CONTRACT NO. 1797

OHIO RIVER TUNNEL

ADDENDUM No. 5

All bidders bidding **Contract No. 1797** shall read and take note of this **Addendum No. 5**. The Contract Documents for **Contract No. 1797 – Ohio River Tunnel** are hereby revised and/or clarified as stated below.

www.alcosan.org

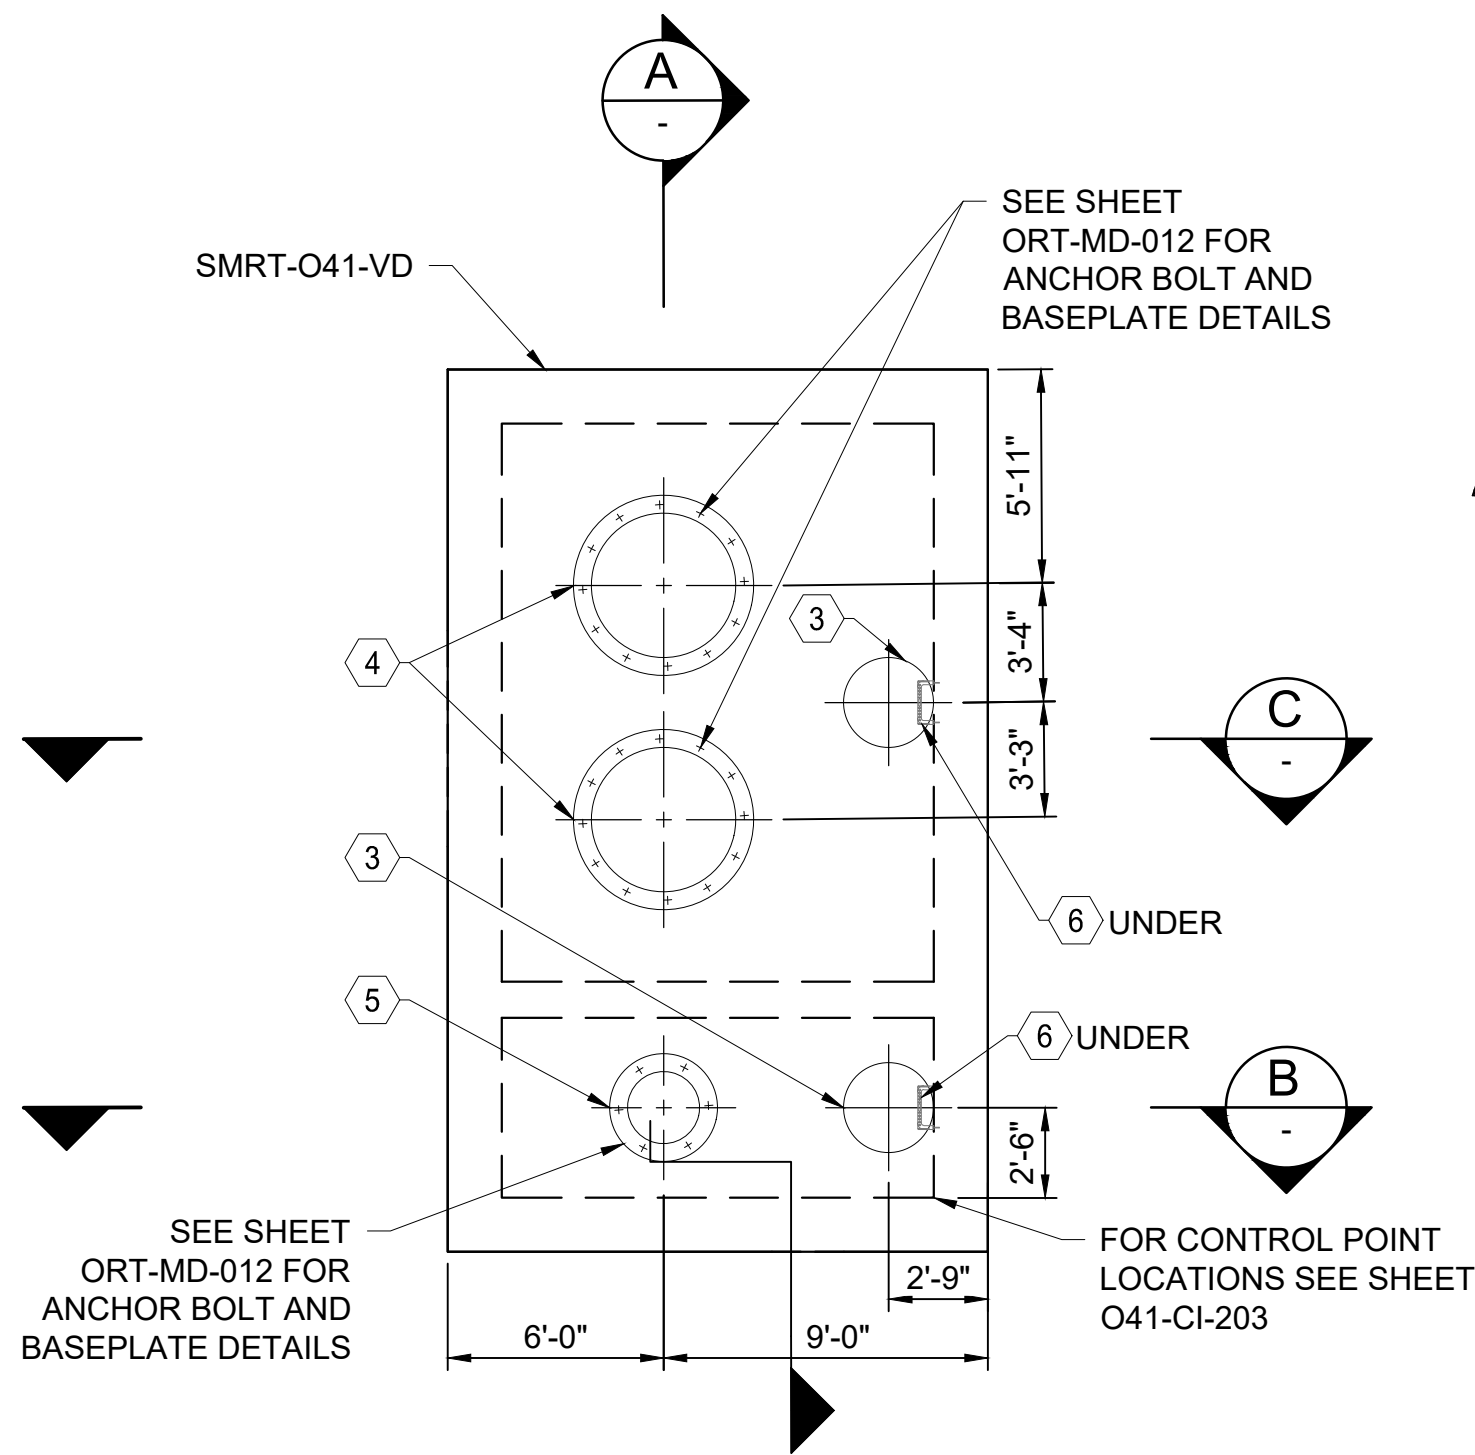
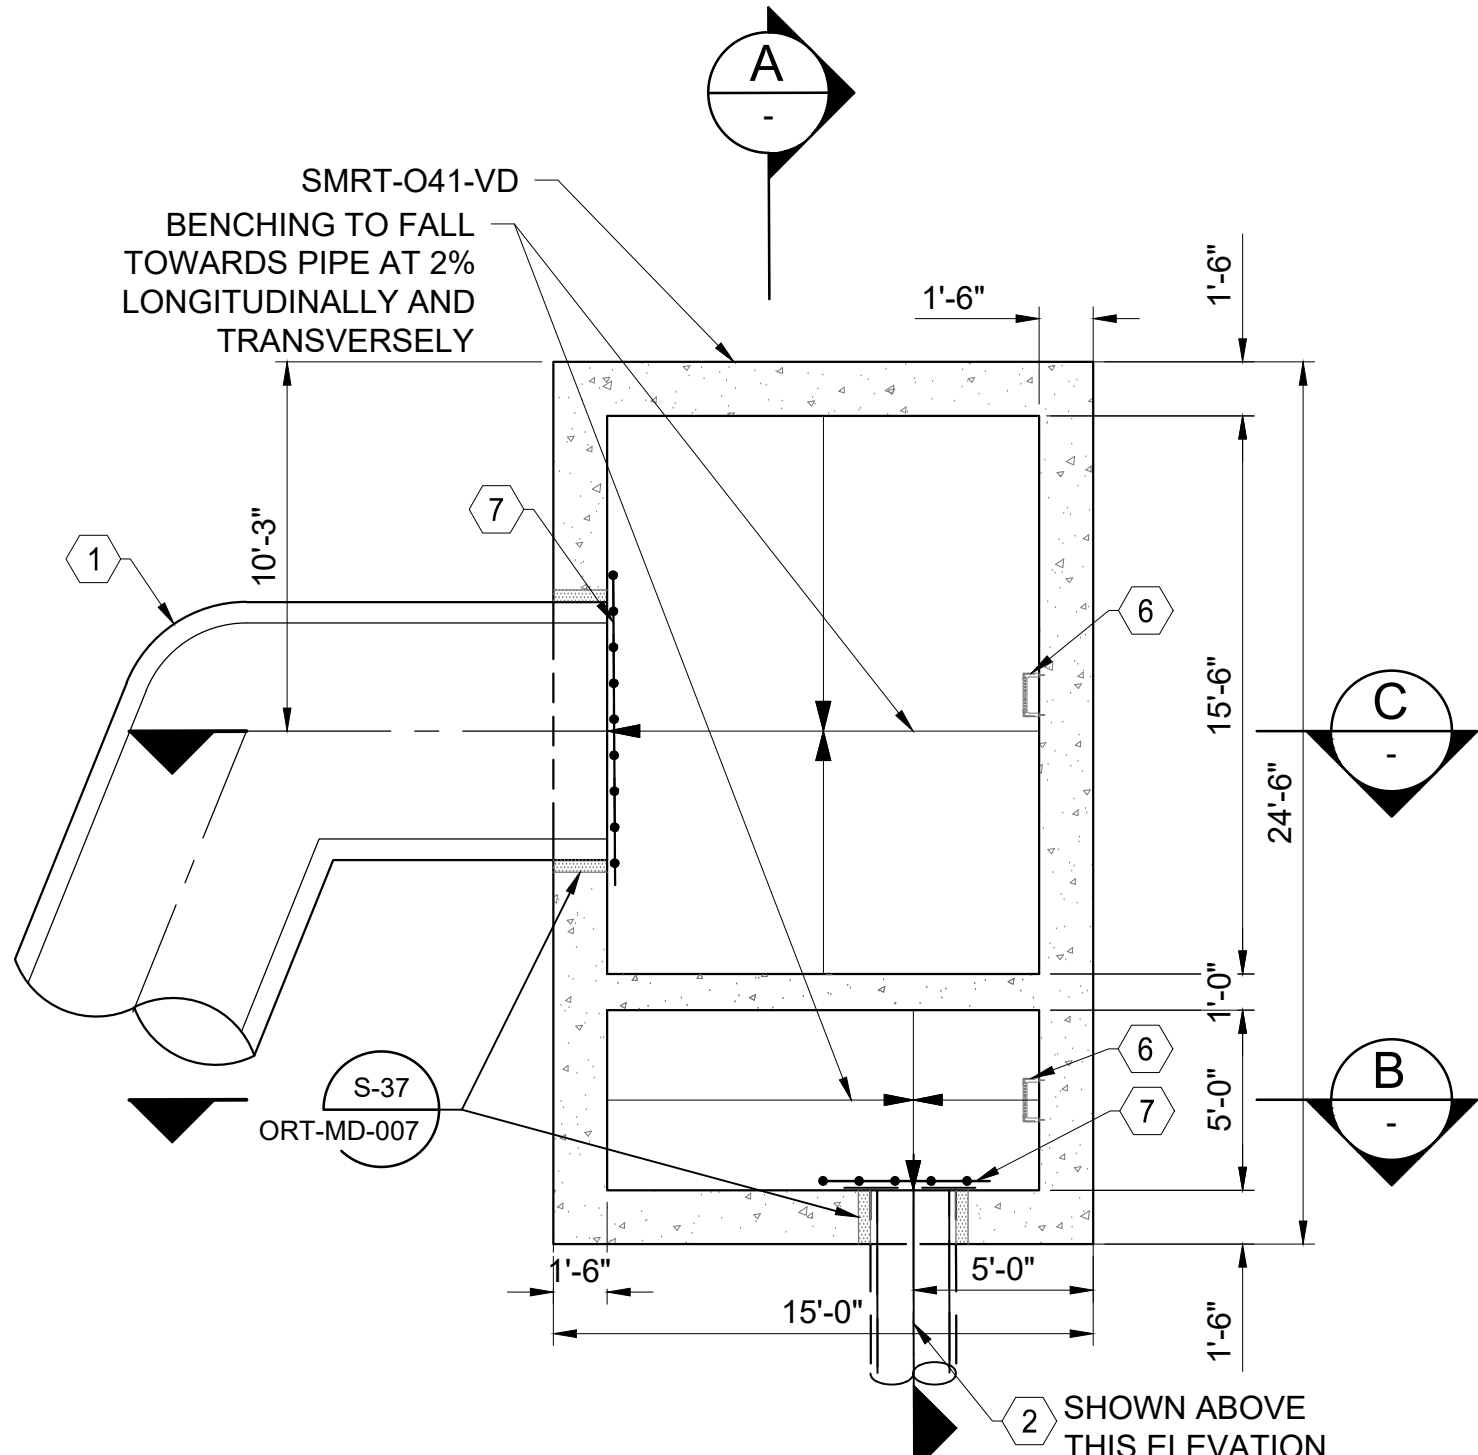
- A2 **This is a dedicated full-time position.**
- Q3 *Ventilation Diffuser SOE - For all sites that contain ventilation diffusers, a support of excavation design is to be designed by the contractor, and submitted to the owner for review and approved. The contract drawings reference in the support of excavation notes under note C, "Any excavation for the ventilation vaults deeper than 4 feet shall be supported by a temporary excavation support system without internal bracing or any elements of the SOE system intruding into the excavation footprint."*

- Please remove these internal bracing restrictions to allow the Contractor and their Engineer to determine the best solution for shoring these excavations.*

- A3 **Drawings O27-ST-142, O27-ST-143, O41-ST-226, A48-ST-315, A58-ST-438, A58-ST-440 O14-ST-628, O07-ST-713, O06A-ST-814, and O06A-ST-815 are revised and attached to this Addendum. See CHANGES TO CONTRACT DOCUMENTS section below and Attachment A of this Addendum.**

- a) DELETE O27-ST-142 (Sheet 245 of 770) and ADD Revised O27-ST-142 (Sheet 245 of 770), which is Attachment A to this Addendum.
- b) DELETE O27-ST-143 (Sheet 246 of 770) and ADD Revised O27-ST-143 (Sheet 246 of 770), which is Attachment A to this Addendum.

Designed by:	HTV	REV No.	DATE	REVISION	DESCRIPTION	APPV	PSK
Drawn by:	JMS	1	10/03/25		SOE NOTE UPDATE		
Checked by:	PSK
